ADDENDUM 1
RFB #17-0038
RONALD REAGAN BUILDING RENOVATION-FLOORS 4,5,6

**RONALD REAGAN BUILDING RENOVATION – FLOORS
4,5,6
Sedgwick County**

Prepared by:
Schaefer Johnson Cox Frey Architecture, Inc.

1 LEVEL 5 DEMOLITION PLAN
1/8" = 1'-0"

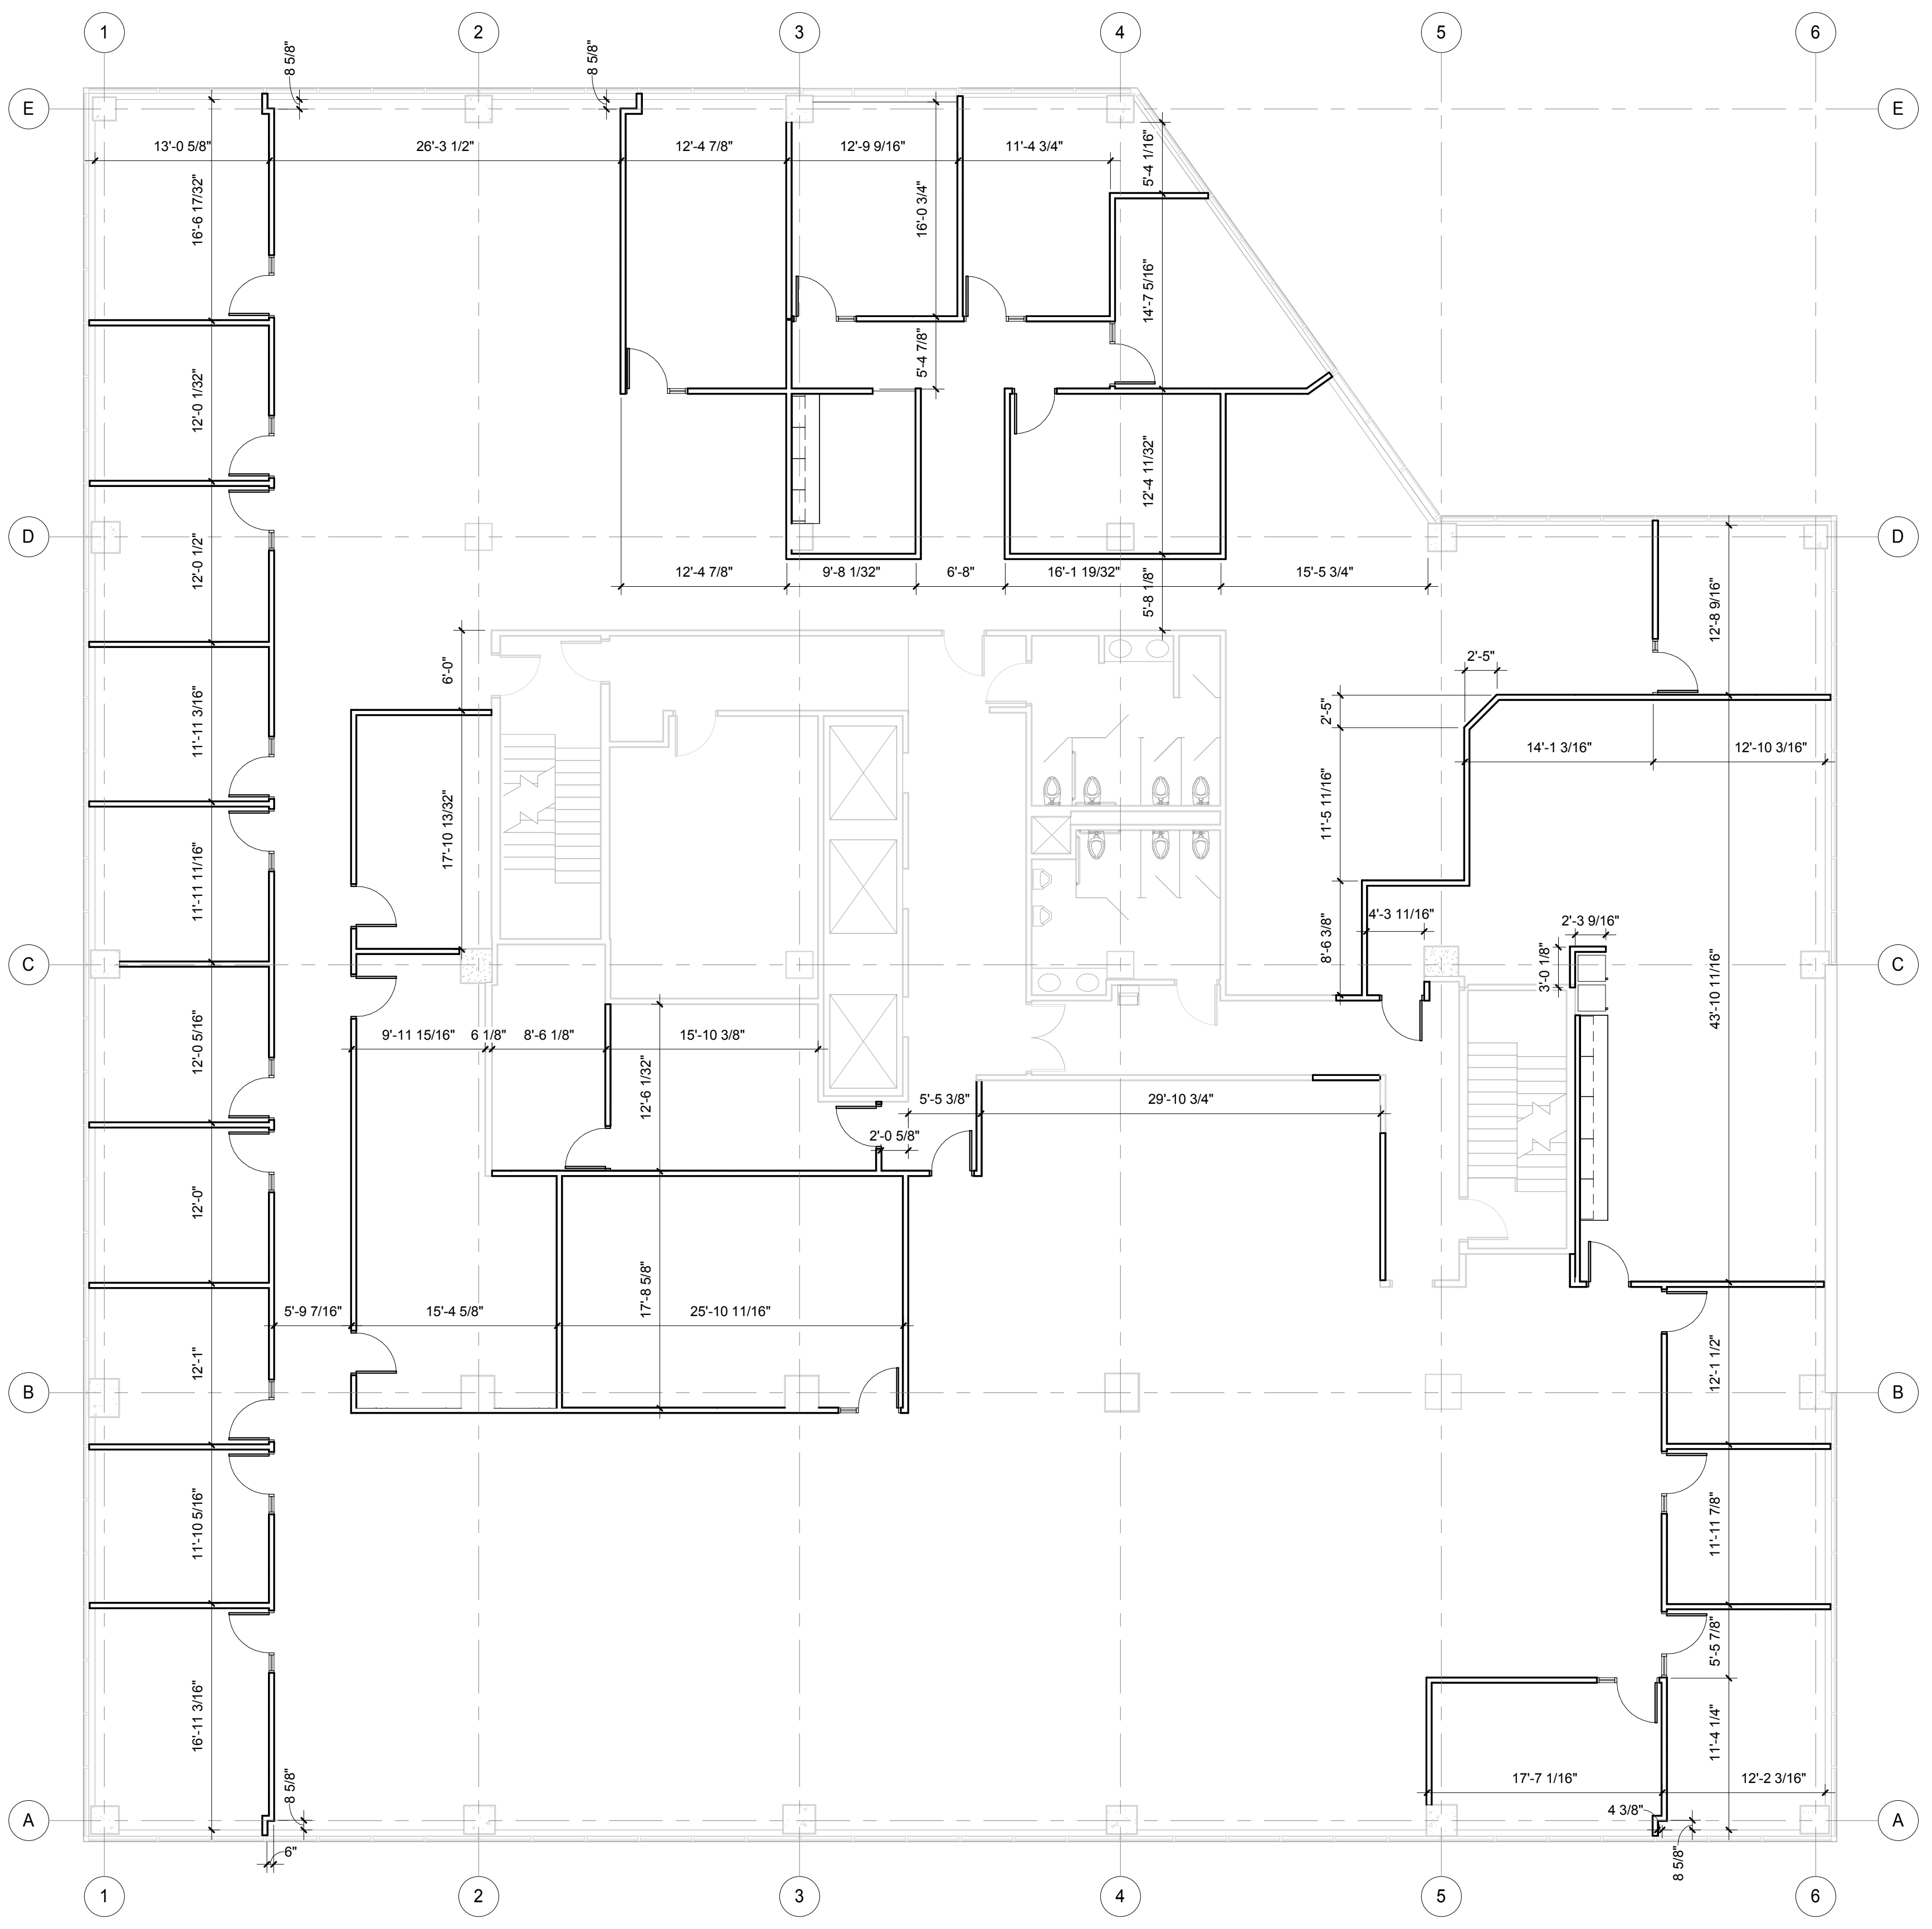
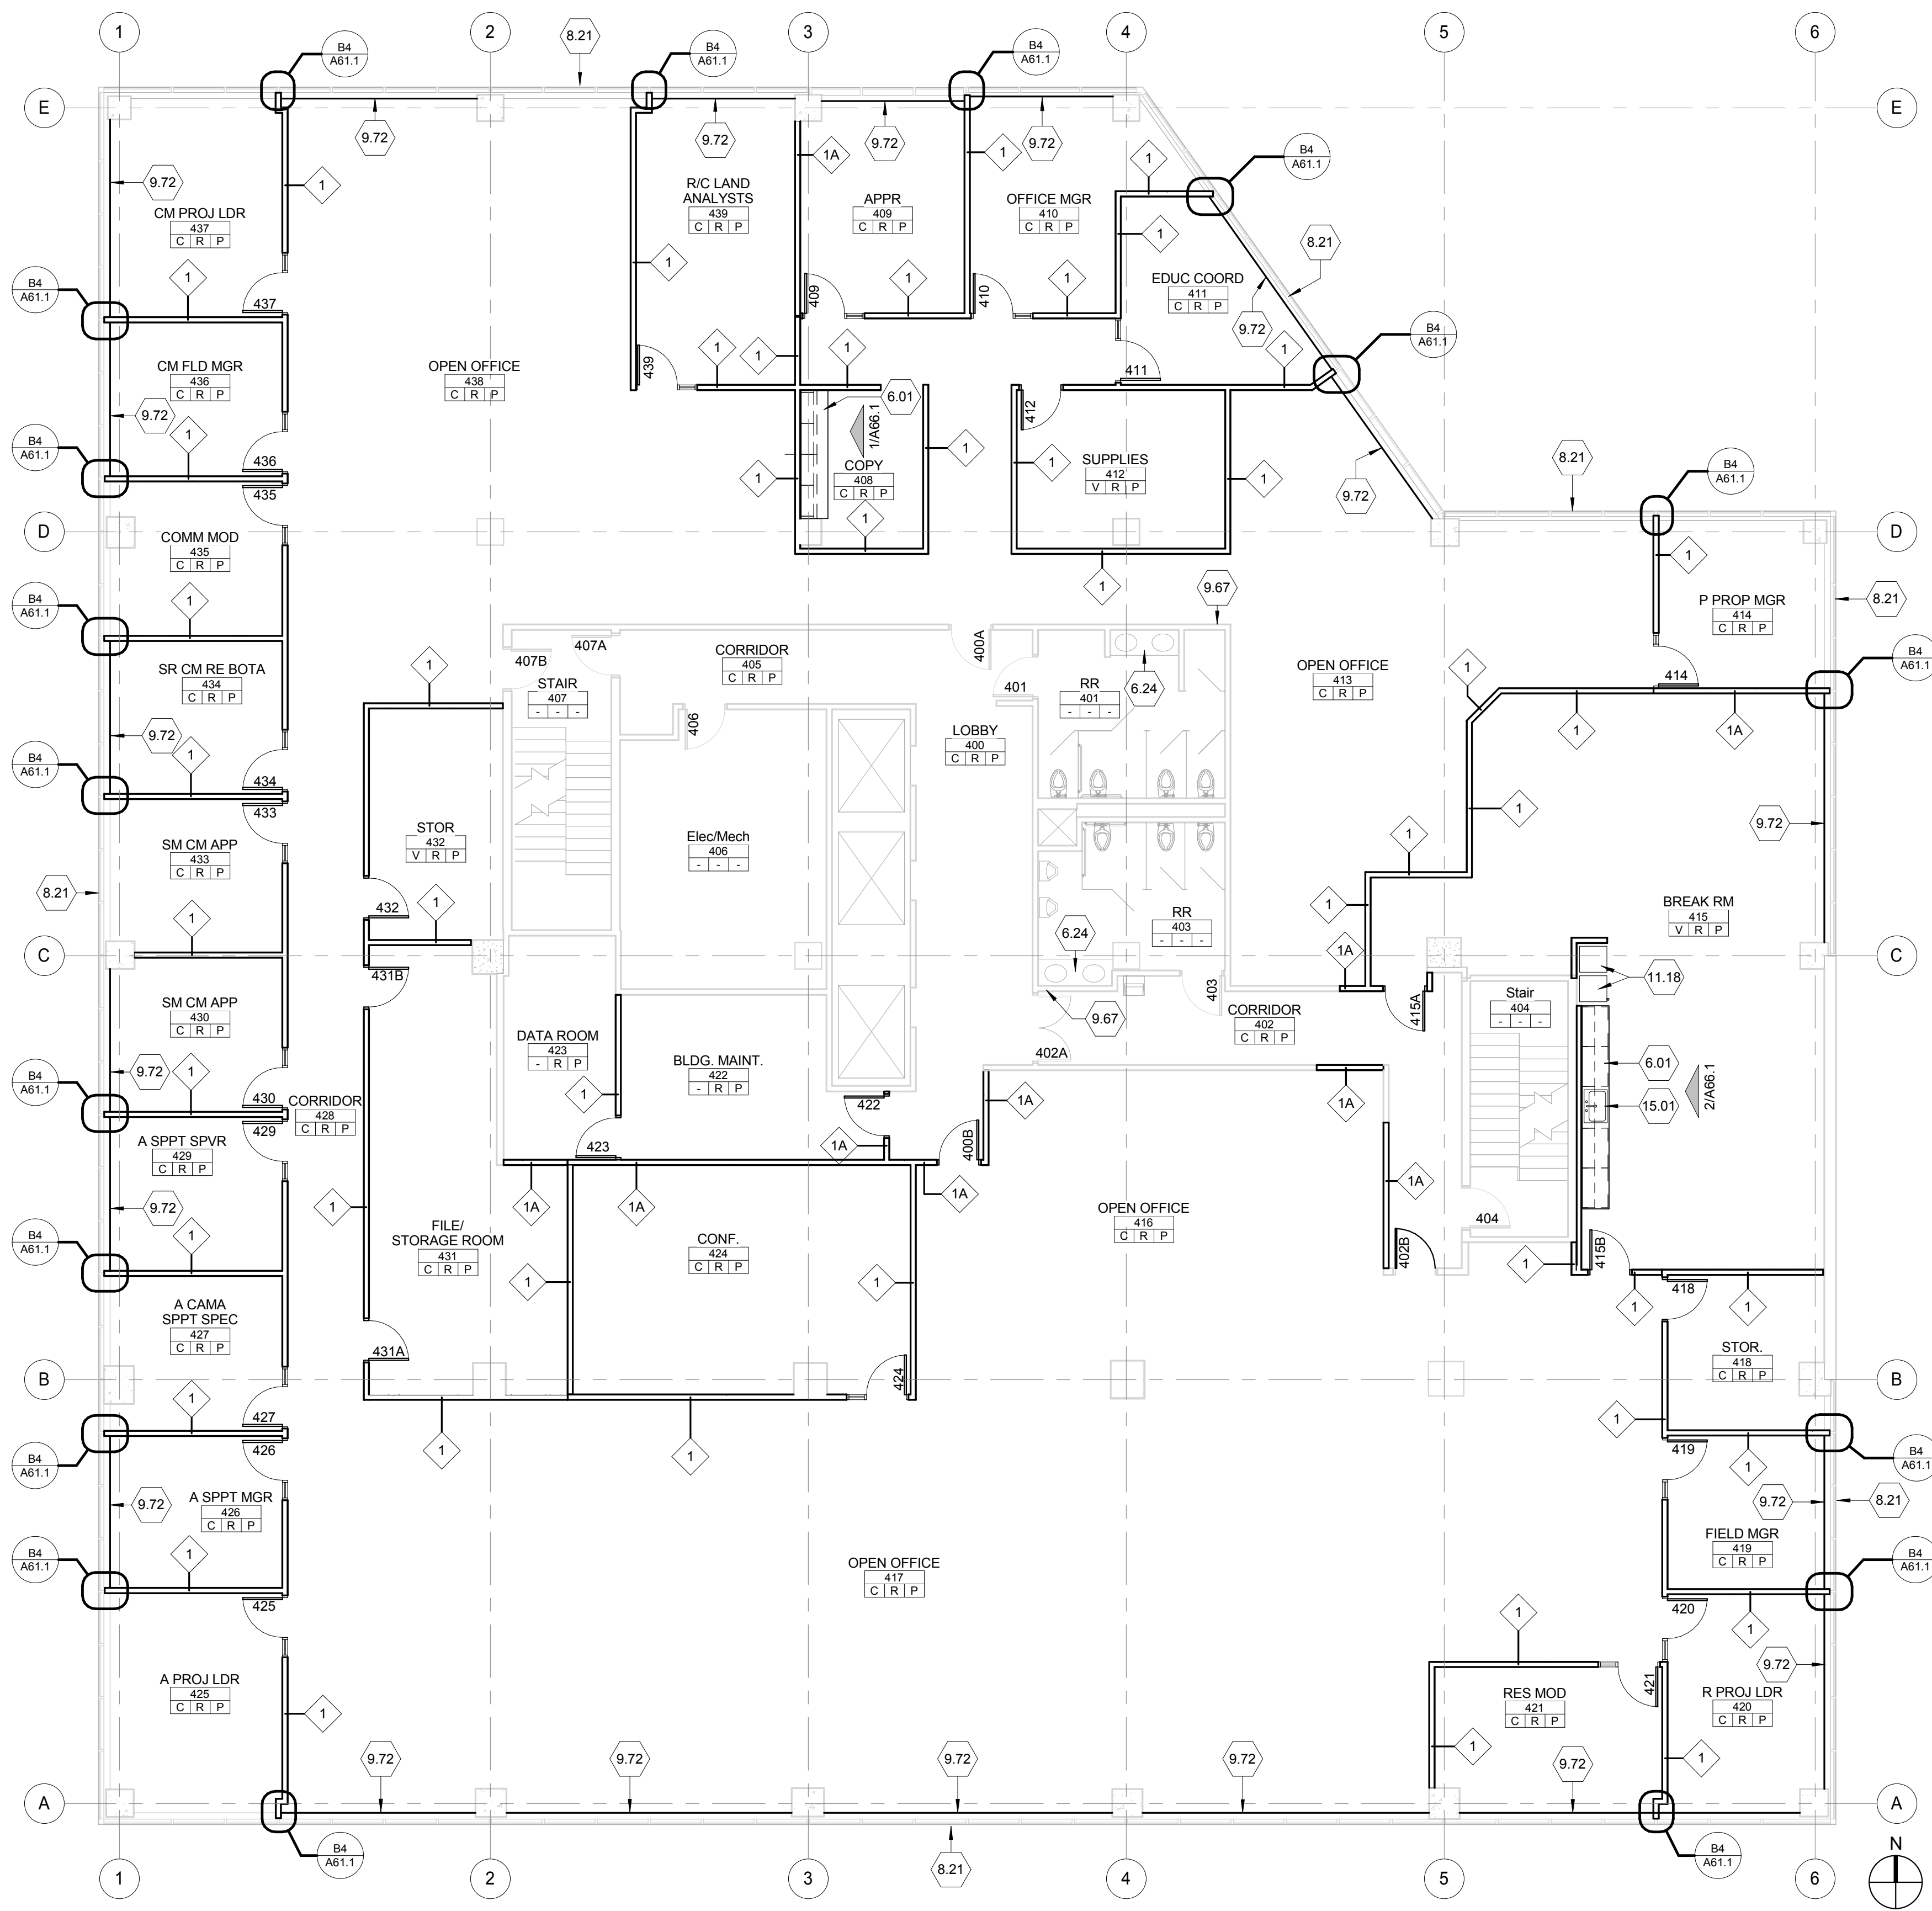
ITEM AD1-A03 DRAWING SHEET A21.2, KEYED NOTES:
REVISION Add keyed note D81 to keyed notes list and Level 5 Demo Plan per attached.
